**Town of Southern Pines Planning Board Regular Meeting
Douglass Community Center
January 20, 2022 at 6:00 PM**

Subject: PD-12-21: Planned Development - Preliminary Development Plan for Phase 1 of the Waterworks mixed-use development; Applicant: Andy Bleggi, PTAH Corporation; Authorized Agent: Kevin Lindsay of Crawford Design.

Date: January 20, 2022

Subject: PD-13-21: Planned Development - Preliminary Development Plan for the new development of a retail building; Applicant: Ubuntu Developer LLC, Sanjeev Bhunta; Authorized Agent: Kevin Lindsay of Crawford Design Company

1 Front Elevation (Facing Road)
 G1.1 1/8" = 1'-0"

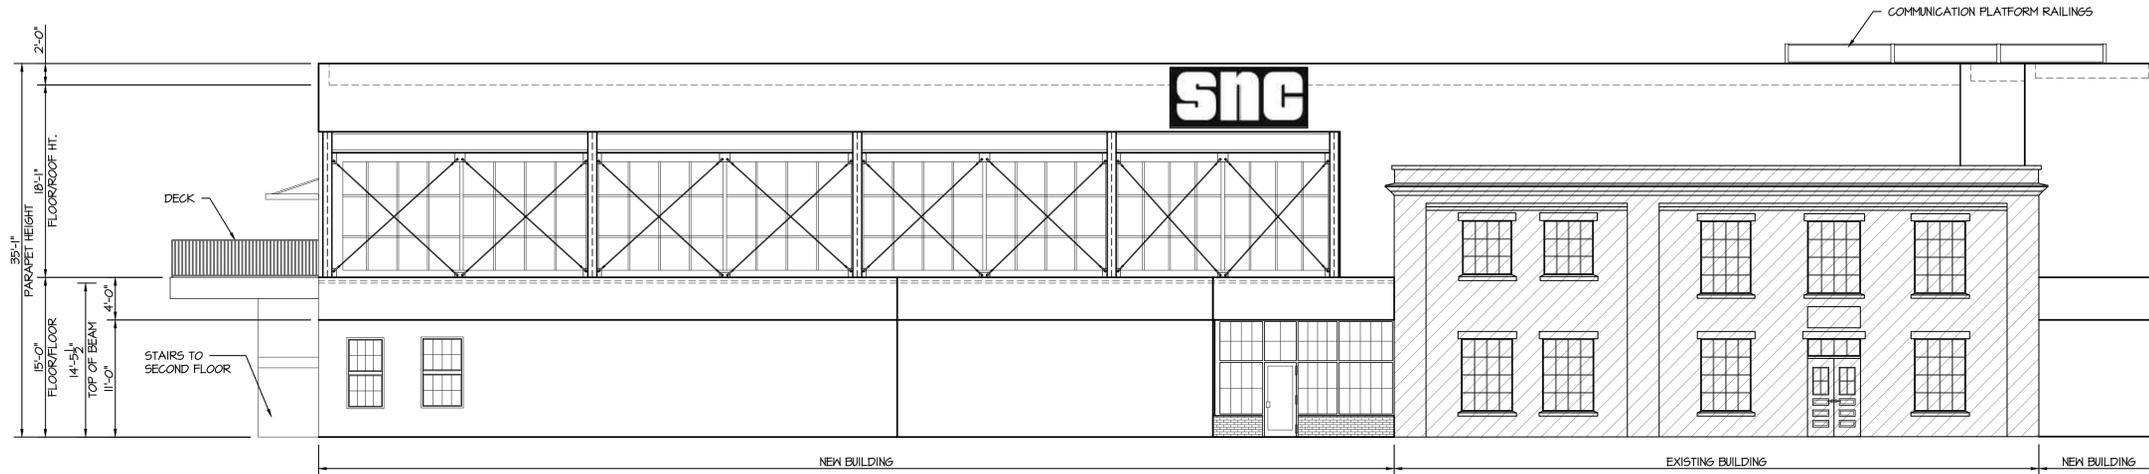
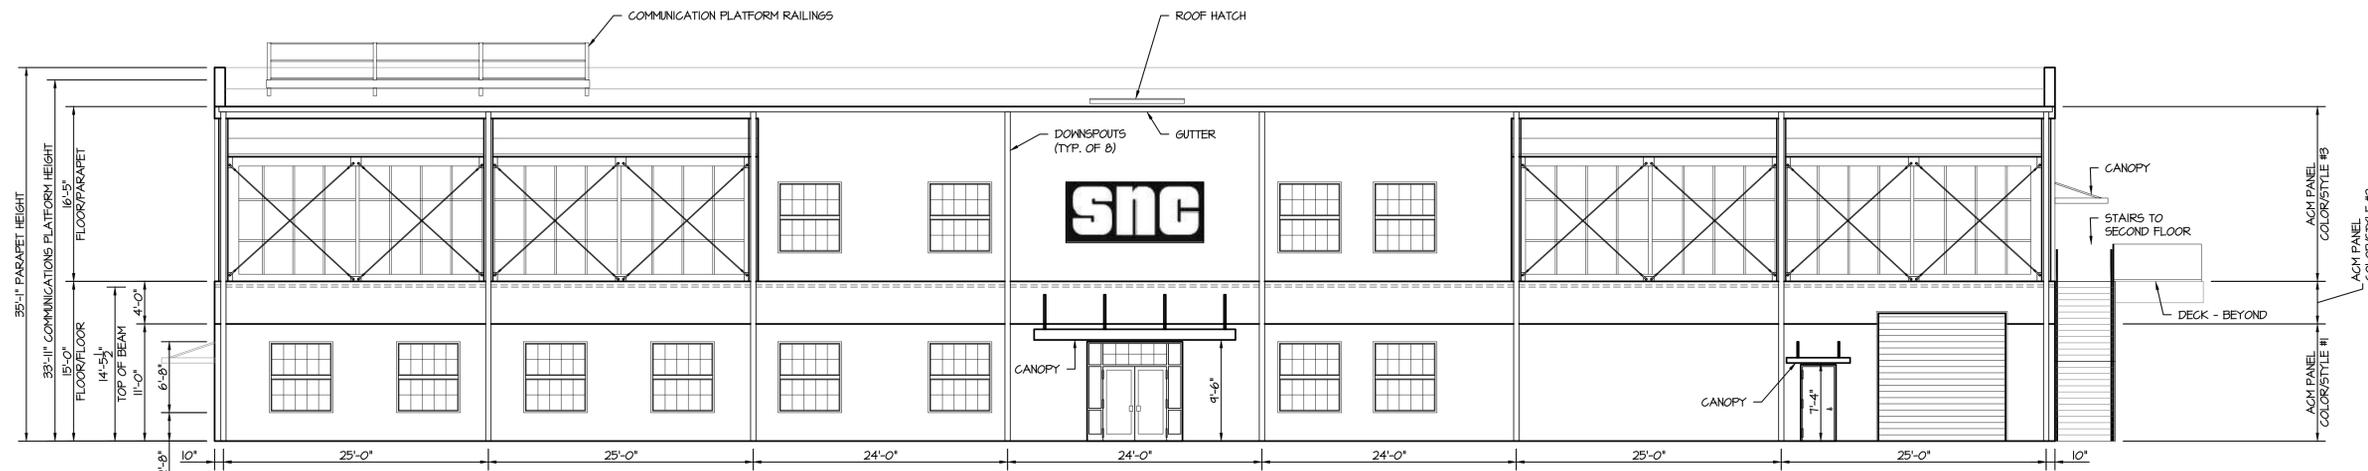
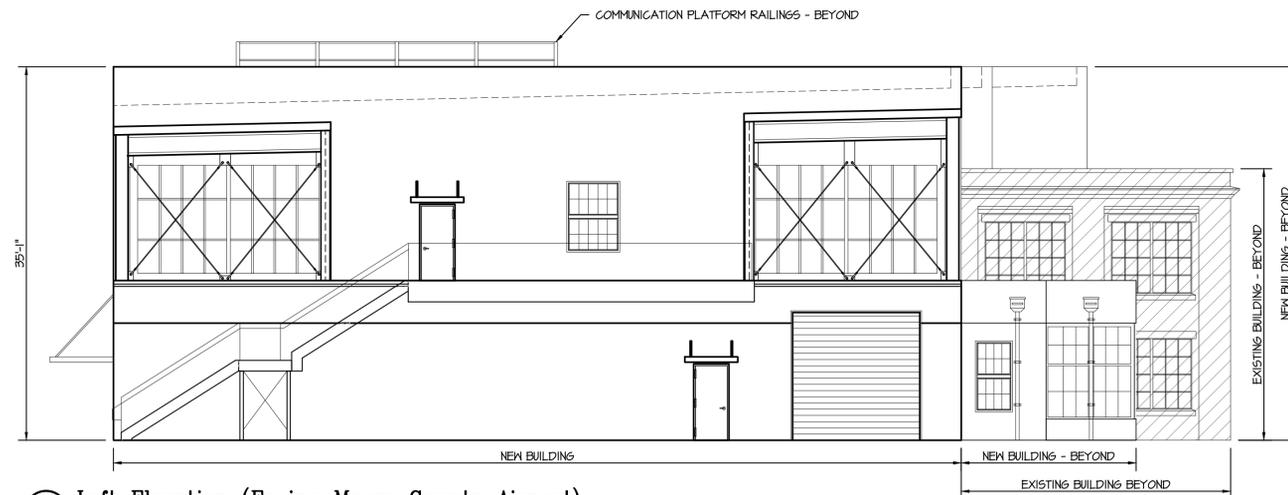
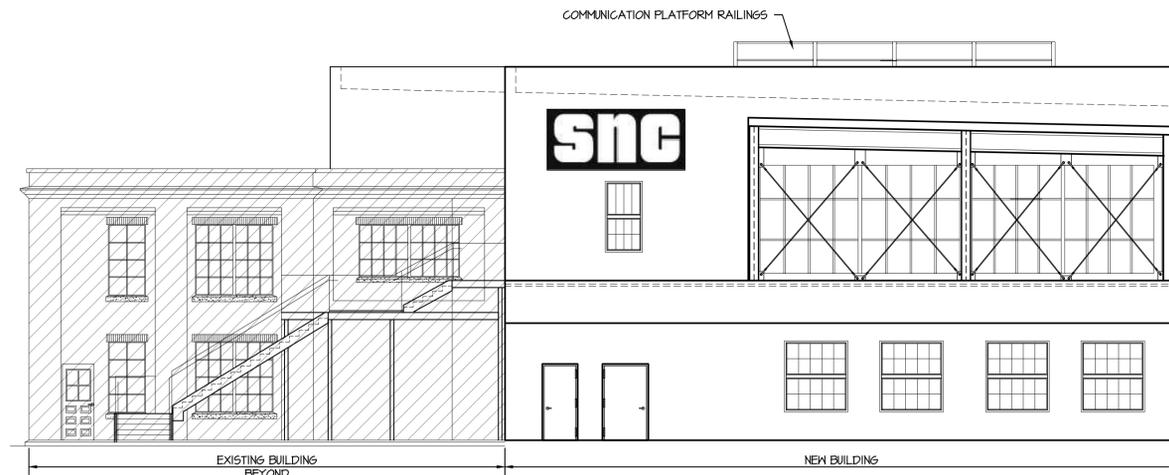
- No deviations to signage standards have been requested and no deviation is contemplated or approved as part of this PDP. Therefore, all signage must comply with UDO §4.06 per Section 5.5.7 of the approved Waterworks CDP. Three large "SNC" wall signs as depicted on the building elevations will not be permitted.

WATERWORKS REVISED PHASE 1
PRELIMINARY DEVELOPMENT PLAN (PDP)

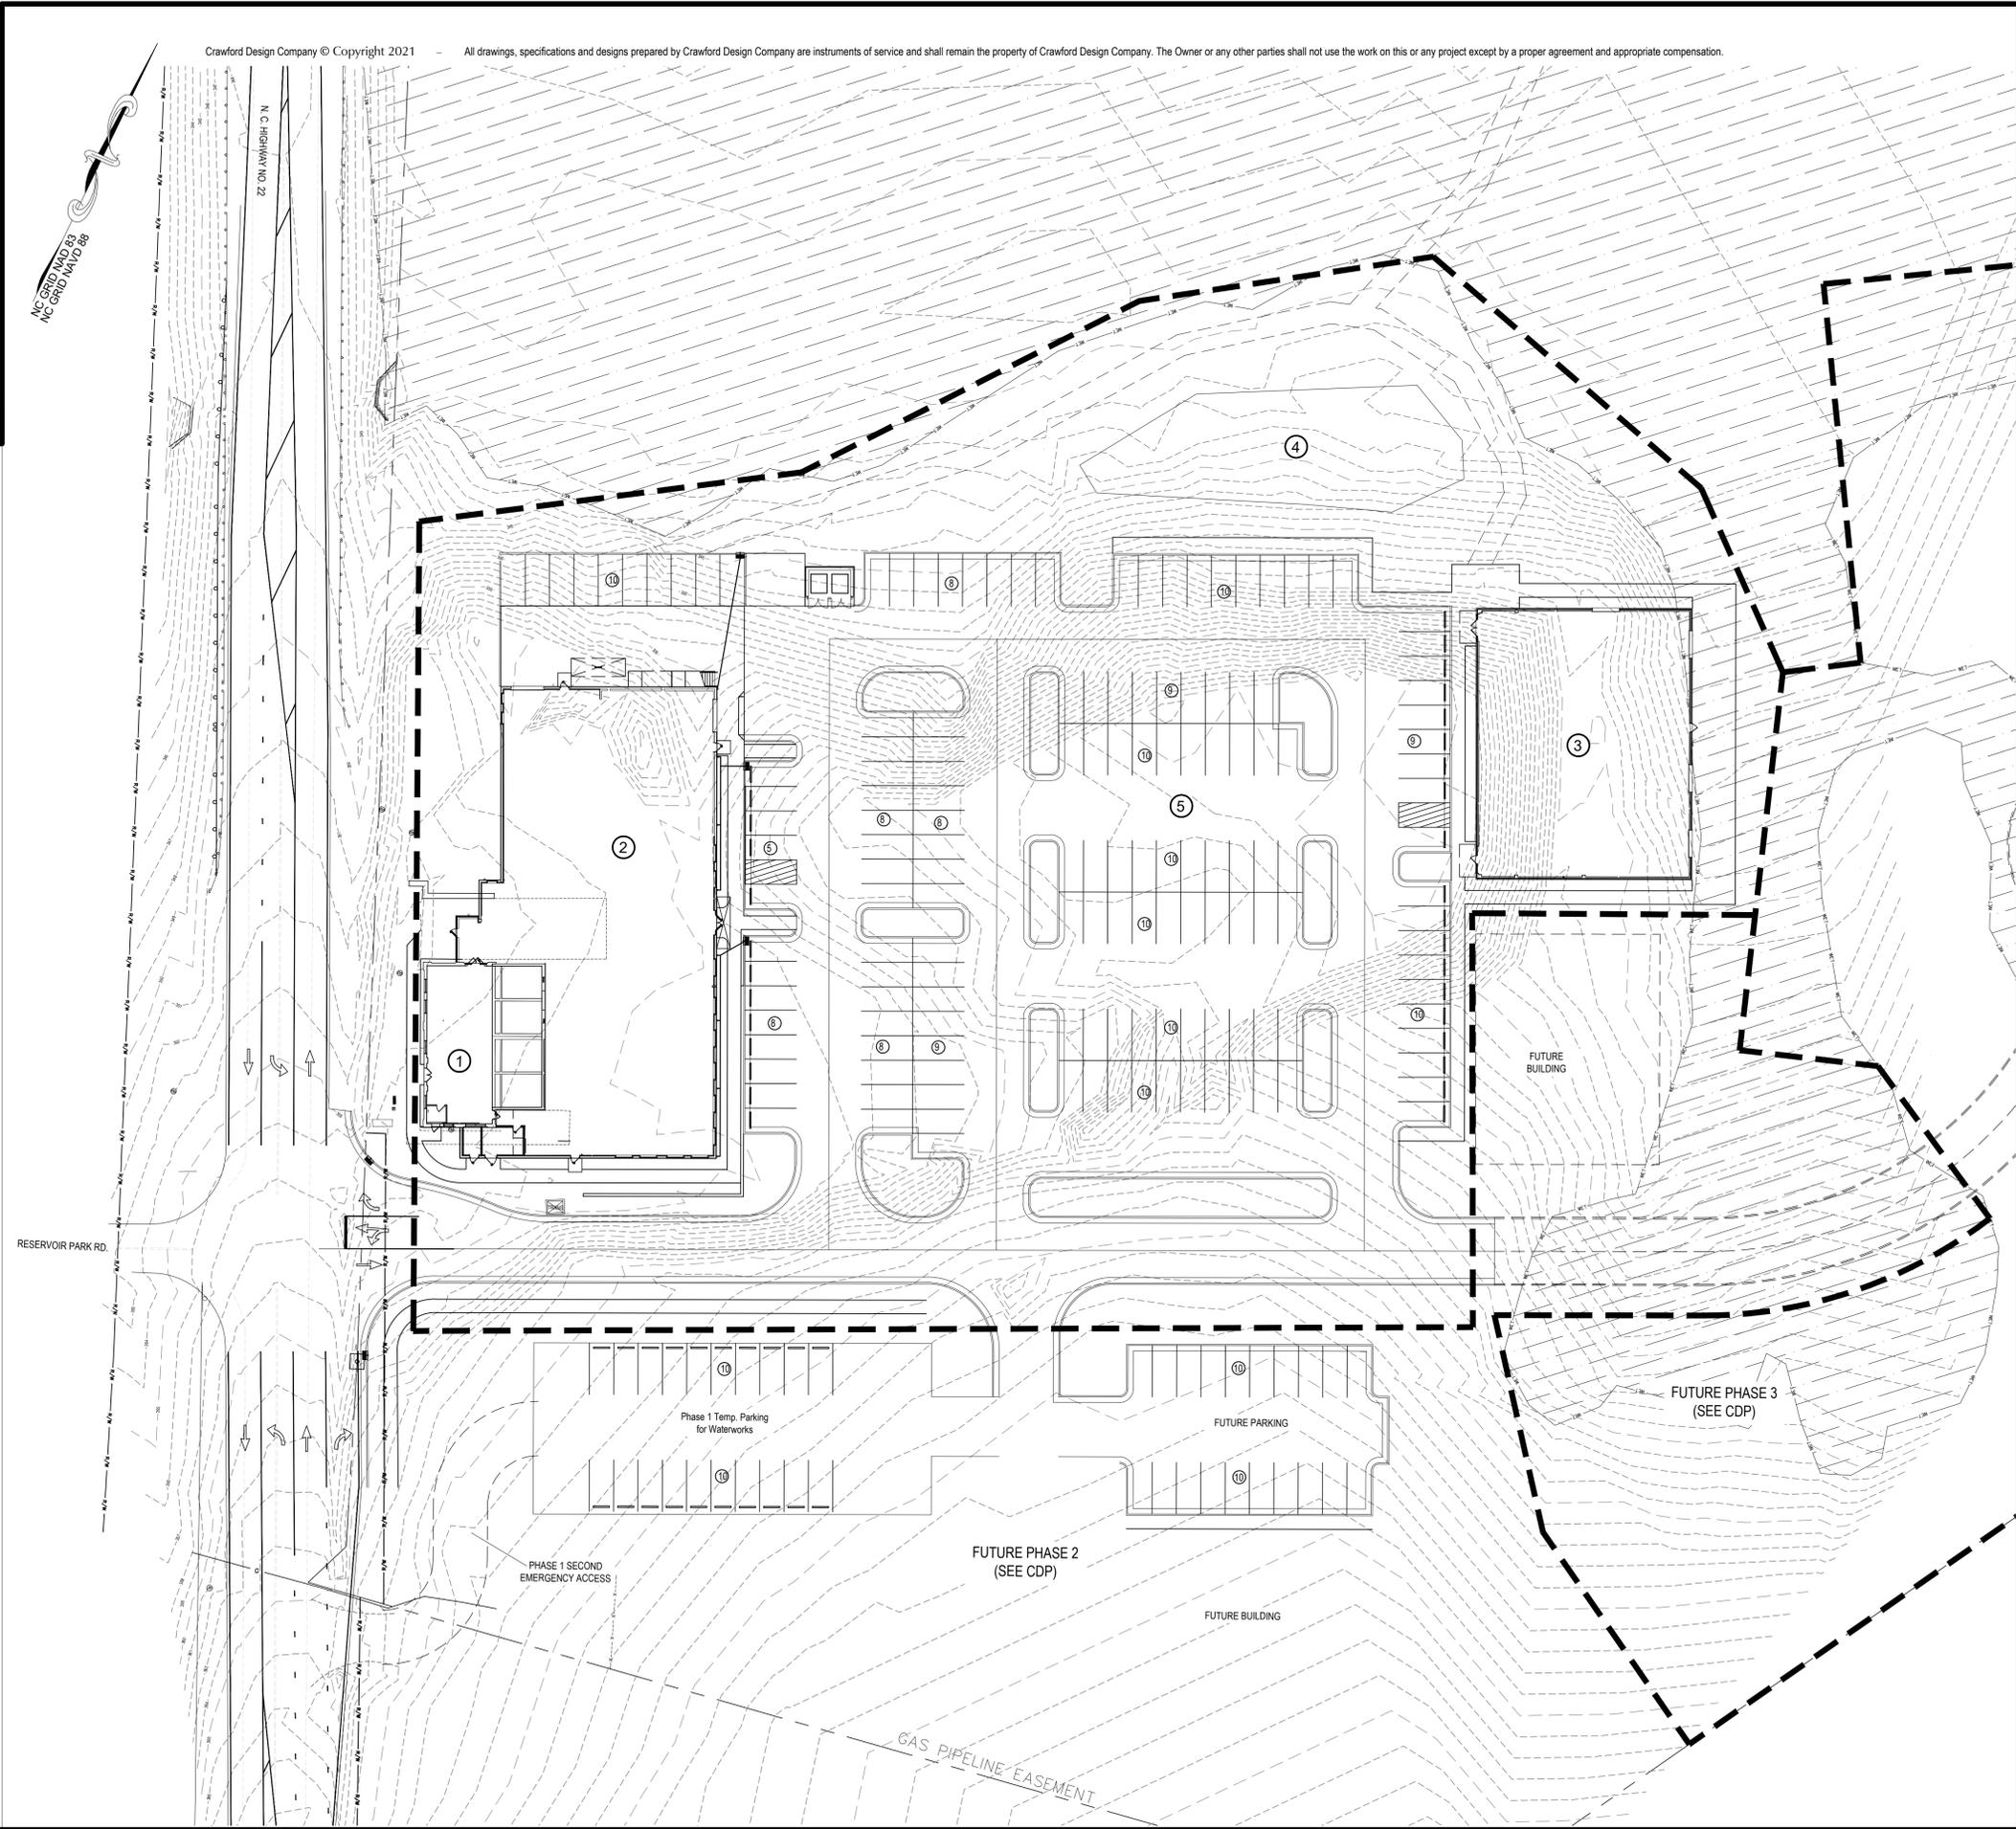
- Phase 1 of Waterworks will include development of a proposed walking trail. The trail will connect from the existing Greenway path on the north side of the property south to the proposed Phase 1 development. The location of the south end of the walking path is depicted on the Phase 1 PDP site plan. The walking path will be designed and reviewed with Phase 1 site plan review.

- A substantial portion of Phase 1 will be allocated to parking in excess of the minimum number of spaces required by the UDO. The applicants are proposing 152 spaces with Phase 1, plus 20 additional temporary gravel spaces with Phase 1 that are located in Phase 2.
- Private drives and yards internal to Waterworks Phase 1 will be reviewed for compliance with the private drive and yard cross-sections found in Exhibit X of the Waterworks CDP.
- All other design standards not addressed as deviations in the Phase 1 PDP will be reviewed for compliance with the UDO and/or CDP, as applicable, during site plan review and Architectural Compliance Permit review.
- Final Development Plans pursuant to UDO §2.18.7 will be required to demonstrate compliance with the Preliminary Development Plan.

Figure 18

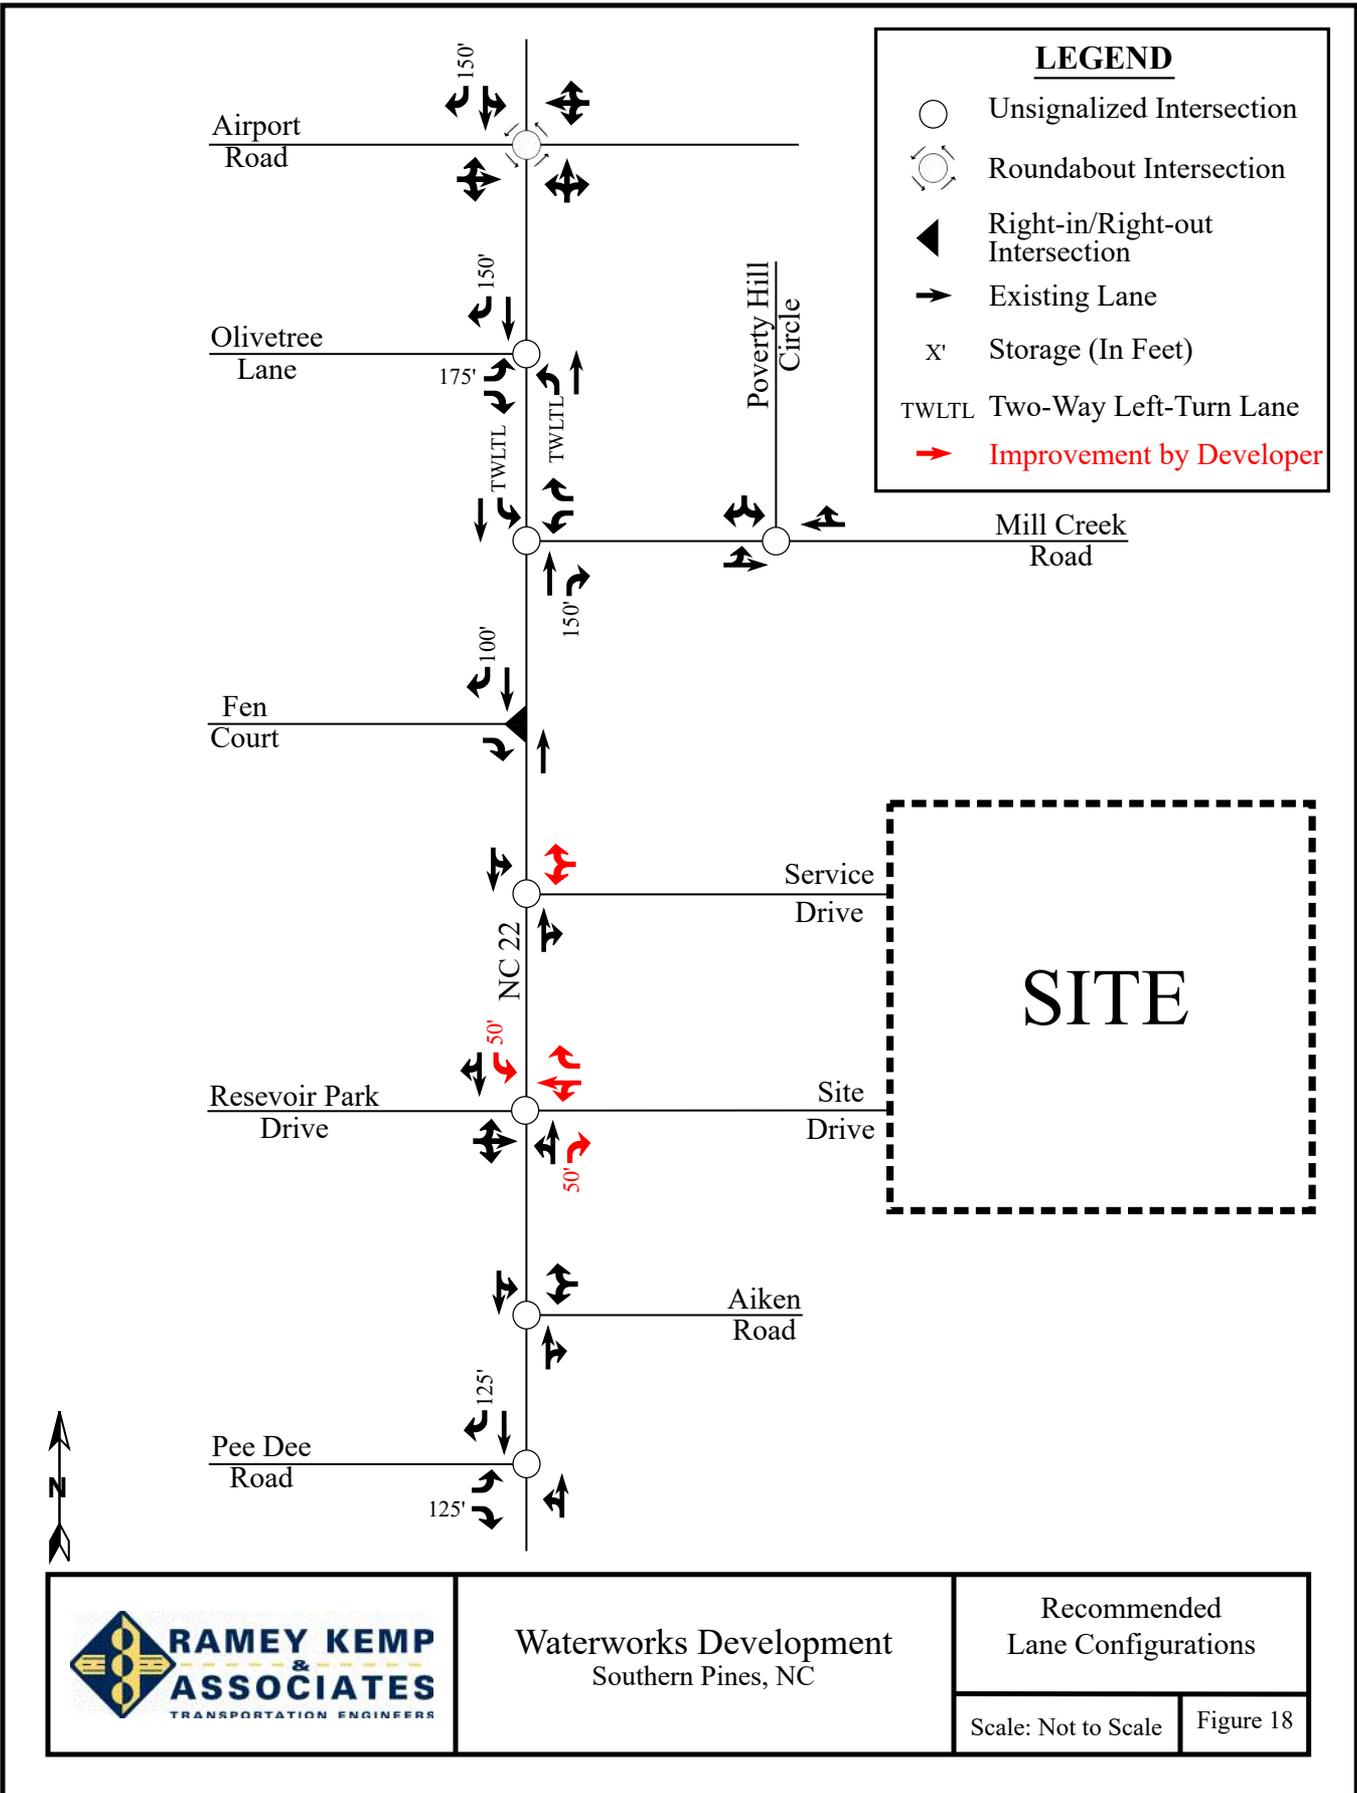
- We agree with the TIA recommendation to provide site access via a full movement intersection to align with Reservoir Park Drive and provide one ingress and two egress lanes.
- We agree with the TIA recommendation to provide stop control for the site drive.
- We agree with the TIA recommendation to construct an exclusive northbound right-turn lane on NC 22 with 50 feet of storage and appropriate taper.
- We agree with the TIA recommendation to construct an exclusive southbound left-turn lane on NC 22 with 50 feet of storage and appropriate tapers.
- Provide an internal protected stem with a minimum length of 100 feet for the site driveway.

- We agree with the TIA recommendation to provide site access via a full movement intersection and provide one ingress and one egress lane.
- We agree with the TIA recommendation to provide stop control for the service driveway.
- We agree with the TIA recommendation to provide restricted access signage for service vehicles only.
- Provide an internal protected stem with a minimum length of 100 feet for the service driveway.

- Please provide potential roundabout mitigation for the reduction in level of service.

This was recently changed to 75 feet at DOT's request. Also, a left turn lane into Reservoir Park has been added. Kevin Lindsay
